CONWAY
HISTORIC DISTRICT COMMISSION
JUNE

CONWAY HISTORIC DISTRICT COMMISSION MEETING

**ROBINSON HISTORIC DISTRICT
CERTIFICATE OF APPROPRIATENESS REVIEW
BREEZEWAY CANOPY
1814 ROBINSON AVENUE**

**ROBINSON HISTORIC DISTRICT
CERTIFICATE OF APPROPRIATENESS REVIEW
EXTERIOR REHABILITATION, DEMOLITION, AND
NEW MULTI-FAMILY STRUCTURE
1616, 1620, AND 1624 ROBINSON AVENUE**

Elevations - proposed new apartment building at 1616 Robinson Avenue

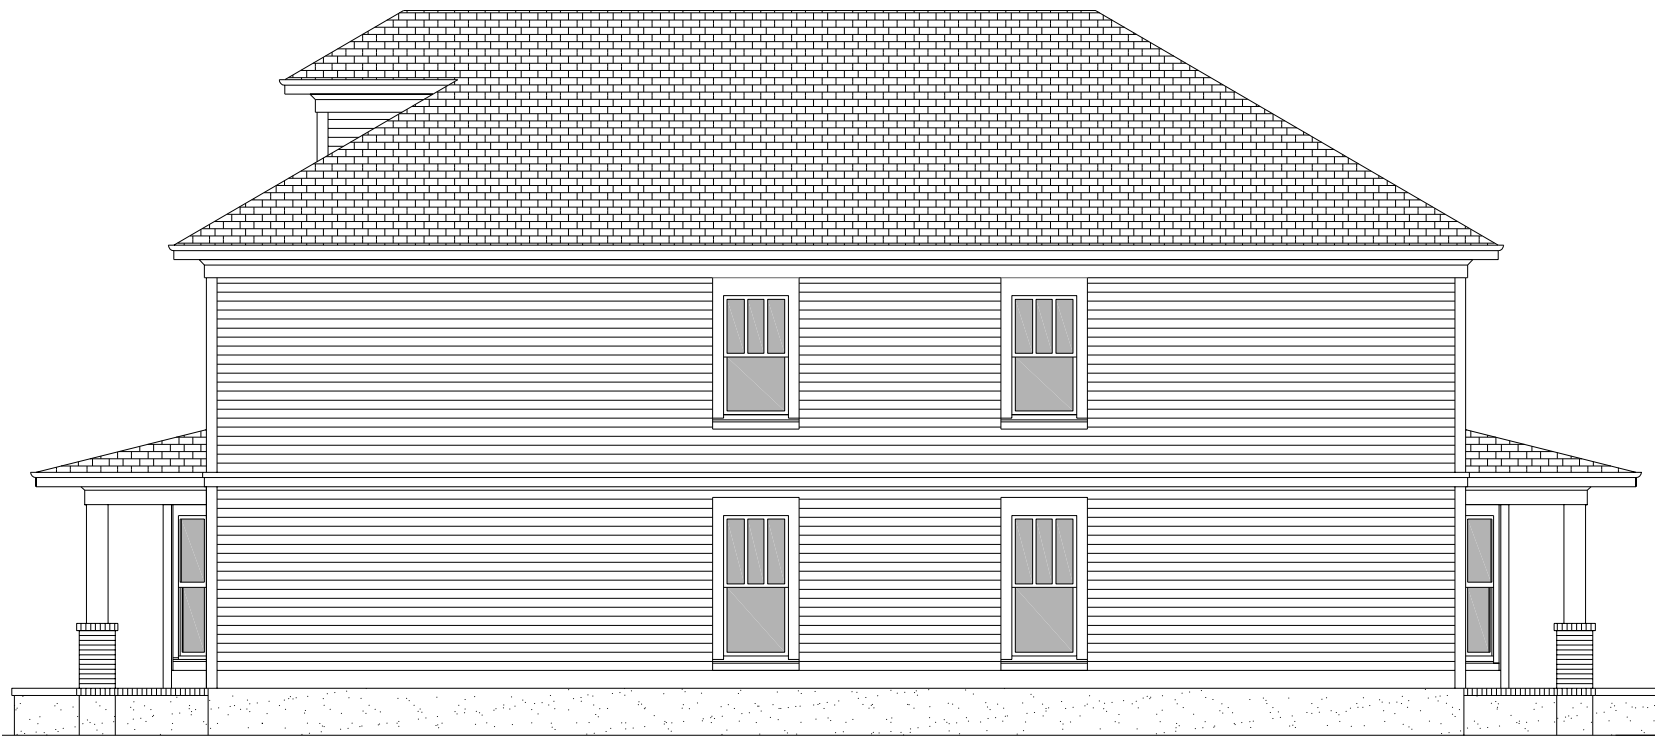
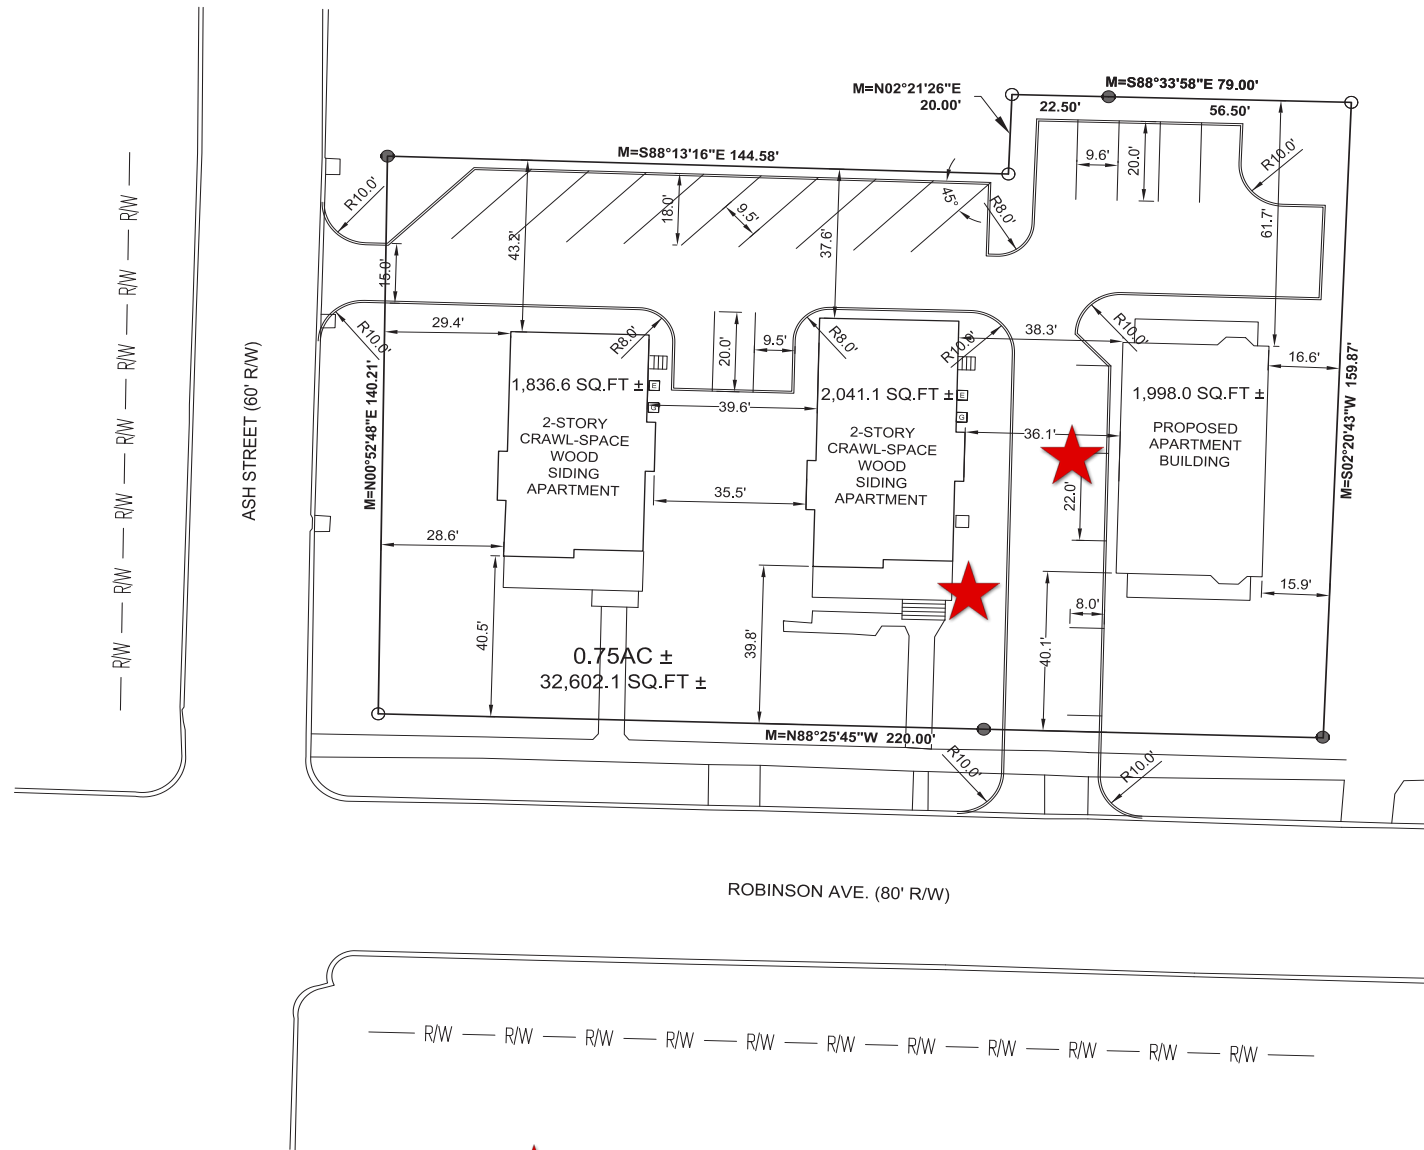
Doors and windows. The existing doors and windows on the historic apartment buildings will be restored. Appropriately sized doors and windows are shown on the elevations of the new apartment buildings. The windows shown are 2 and 3 over one. It is assumed that new windows will use pane dividers and not true muntins. The existing structures have one over one windows. One over one may be preferred on the new structure.

The new apartment elevations show similar detailing to the historic structures; wide trim board is used at the doors and windows, columns appear to be similar size, wide cornice trim is used. Siding should probably be in a narrower style to better match the historic structures. A Hardieboard or similar material is planned.

1. New apartment structure shall be constructed as proposed on submitted elevations and site plan with any changes as required in following conditions.
2. Windows shall have one over one sashes similar to historic apartment buildings.
3. Wide trim around windows and doors shall be used similar to historic apartment buildings. Wide cornice trim band shall also be used. Additional trim and moulding similar to existing historic apartment buildings shall be used on doors and windows on Robinson Ave facade.
4. Hardie-siding or similar cementitious siding shall be used.
5. Trees?
6. Site lighting must be inward downward and shrouded, meeting development review regulations.
7. HVAC equipment must be located at the rear or sides of the structures and screened with a low fence and/or shrubs.

Proposed Site Plan

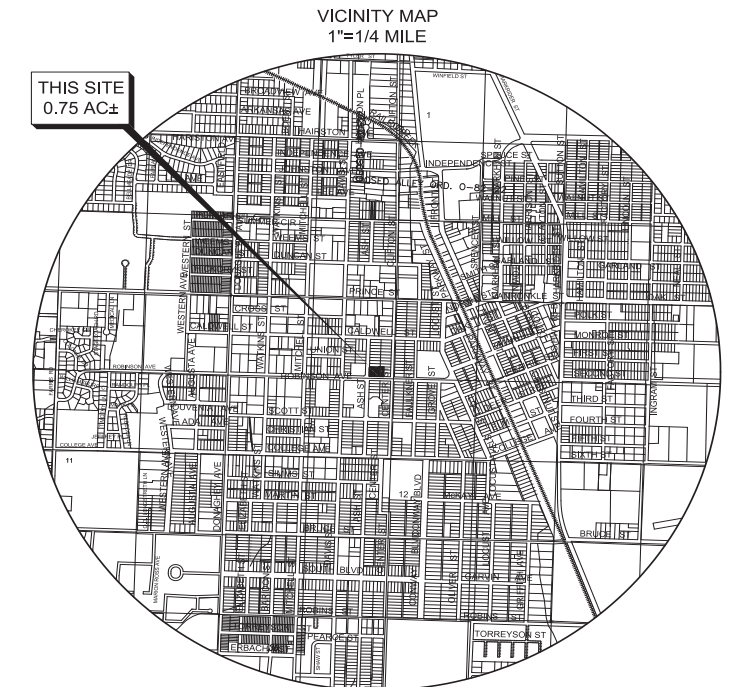
Tree preservation. The majority of large trees on the property would seem to be unaffected. However, there are 2 large pecan trees; one close to the front porch of the east apartment building and the other behind the single family residence. Depending on the amount of disturbance, the pecan close the porch should be ok. The pecan behind the residence will need to be removed. Remediation with a new tree could be considered, however, there are ample large trees on the property.

Awnings. When new construction uses awnings, traditional awning designs, materials, and placement should be used. No awnings are proposed. The width of the "throat" of the new entry drive could possibly be reduced to present a more residential sized driveway. It could then widen to accommodate parallel parking.
